CITY OF RIO RANCHO
DEPARTMENT OF FINANCIAL SERVICES
PURCHASING DIVISION
3200 CIVIC CENTER CIRCLE NE 3rd FLOOR
RIO RANCHO, NEW MEXICO 87144
TELEPHONE: 505-896-8769 FAX: 505-891-5762

ADDENDUM NO (1) ONE
IFB 20-PW-032
Broadmoor Boulevard Extension Project

June 18, 2020

MISCELLANEOUS PAVEMENT SECTION

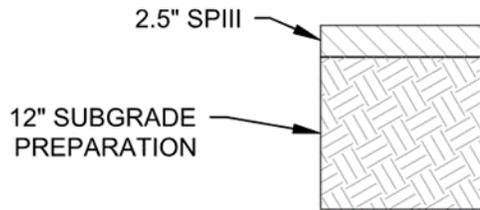
2. **Question:** The Misc. Asphalt detail calls for 8” base course under the 2.5” Asphalt pavement. The cross section calls for just 2.5” asphalt, not showing the aggregate base, also on the surfacing schedule, the 8 “ Base Course quantities do not show base course quantities for the paved ditch (misc. pavement). Do we include the 8” base in the misc. paving item? Does it need to be added to the Base course quantity? Or are we not putting any base under the misc. asphalt?

- Sheet 2-1, from Broadmoor Blvd & Paseo Del Volcan Intersection Improvements Plan Set, remove MISCELLANEOUS PAVEMENT SECTION and replace with detail below.

Answer: The Miscellaneous Pavement Section on sheet 2-1 of the Broadmoor Boulevard and Paseo Del Volcan Intersection Improvements plans shall be replaced. Contractor shall Bid 2.5” of SPIII over 12” of Subgrade Preparation. See revised Miscellaneous Pavement Section detail in Drawings Modifications section.

BASE BID: HMA

ADDITIVE ALTERNATIVE: WMA

NOTE: OIL CONTENT FOR SP III SHALL BE PG 70-22
